This letter is in reference to your letter dated May 24, 1996, and subsequent letters and telephone calls, regarding the Model 865 radiography camera (NR-0628-D-118-S). As we discussed, NRC's Region IV-WCFO has reported a concern that the source would be exposed during the maintenance procedures outlined in your users manual. To address this concern, we have amended the registration certificate, NR-0628-D-118-S, to include the following license review note:

This letter is in reference to your letter dated May 24, 1996, and subsequent letters and telephone calls, regarding the Model 865 radiography camera. As we discussed, NRC's Region IV-WCFO has reported a concern that the source would be exposed during the maintenance procedures outlined in your users manual, and we are in the process of evaluating the design of the device to determine whether that is the case. As of the date of this letter, we have still not received sufficient information to complete this evaluation. Therefore, please provide the following information within thirty (30) days of the date of this letter so that we may continue our evaluation:

Enclosed please find the information you requested concerning the mod

ACTUATOR MAINTENANCE

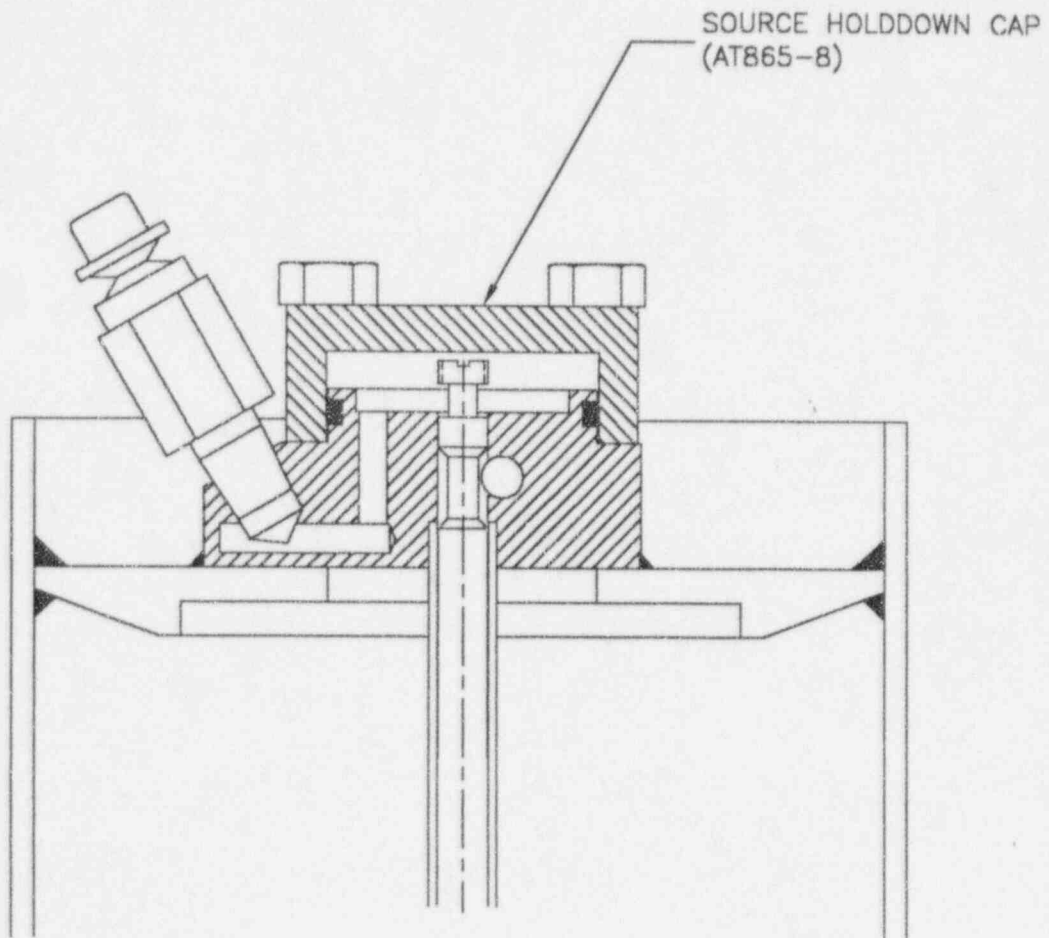
1. Provide a drawing of the bottom of the actuator piston, which shows the keyhole slot.
2. Provide a drawing and description that illustrates how the four hex bolts hold the actuator assembly and the source holddown cap to the device.

3. It appears from the maintenance procedures that after completing step 12, the source is held in the device by only the source holddown cap. Based on the sketch of the source holddown cap supplied in your July 11, 1996, letter, it does not seem that the source is held in position at this point and that the source assembly could move forward and backward along the source tube inside the device, resulting in the source assembly not being properly locked in the shielded position after reinsertion of the locking mechanism. When the source holddown cap is removed in step 23, the source assembly could then be in an unlocked position, with nothing restricting its movement into an unshielded position. Please provide additional details to clarify this situation, demonstrating that the source will be maintained in a shielded position at all times during the maintenance, and that the source assembly will be locked in the shielded position upon completion of the maintenance procedures.

4. Your May 24, 1996, letter states that the piston limiter tool secures the source rod in the stored position during removal of the actuator assembly. From the drawings and maintenance procedures, it does not appear that this is correct. Please clarify.

I have enclosed some sketches that show the view of the 865 during maintenance, depicting the removal of the actuator head, the method of securing the source and the specific tools used as described in our last letter. These depict the information given in the 865 manual, steps 3-29.
